Office Action Summary

10/730,440

NAMUDURI, CHANDRA SEKHAR

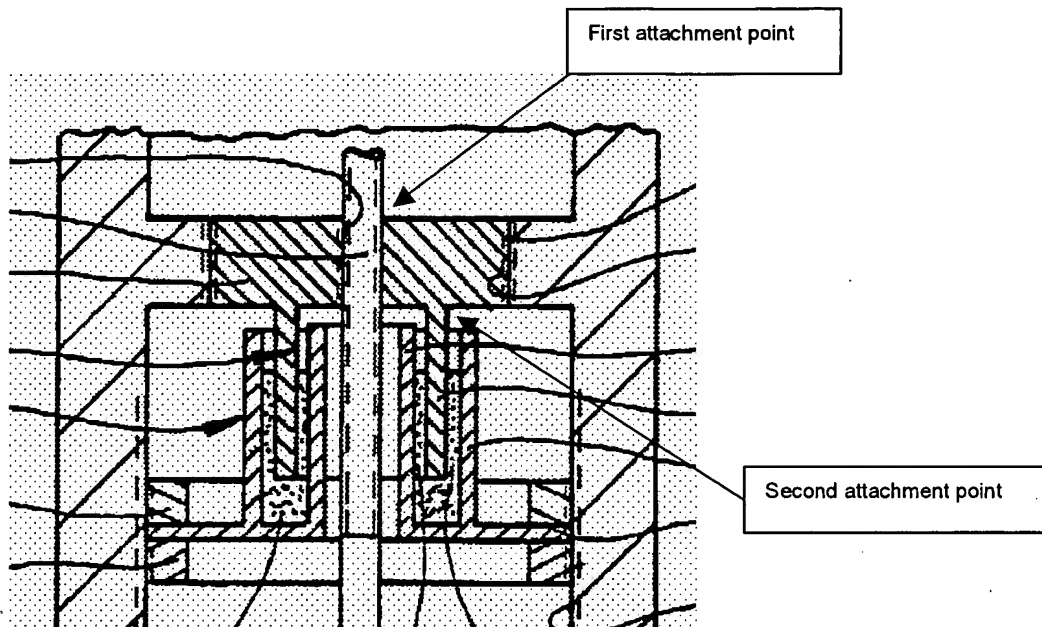
Re: claims 1, 2, 7, and 12. Weyand shows in figure 2 a damping apparatus comprising: a linear to rotary conversion mechanism comprising a translatable member 34 having a first attachment point as shown in the labeled version of figure 2 of Weyand shown on the following page that is adapted for generally linear translation in a forward and a reverse direction and a rotatable member 34 comprising a rotatable shaft that is

rotatably coupled to the translatable member; wherein translation of the translatable member in one of the forward or the reverse directions produces a forward or a reverse rotation of the rotatable member and shaft, respectively, and a damping mechanism comprising a second attachment point as shown in the labeled version of figure 2 of Weyand, a hub 32 that is fixed to the shaft.

Re: claims 6 and 11. Weyand, as modified, describe the invention as set forth above in the rejection of claim 1 and also includes (as shown in figure 2 of Weyand) a housing 14 having a first end shown in the area of the lead line of number 48 with a bore that is adapted to rotatably receive the shaft therethrough, a sidewall 30 having an inner surface and a second end opposite the first end, the hub 32 having an outer surface proximate a portion of the inner surface of the sidewall such that the outer surface of the hub and sidewall of the housing define a channel therebetween as shown in figure 2 of Weyand.

Examiner notes that Weyand clearly shows first and second attachment points in the labeled version of figure 2 of Weyand, as broadly recited.
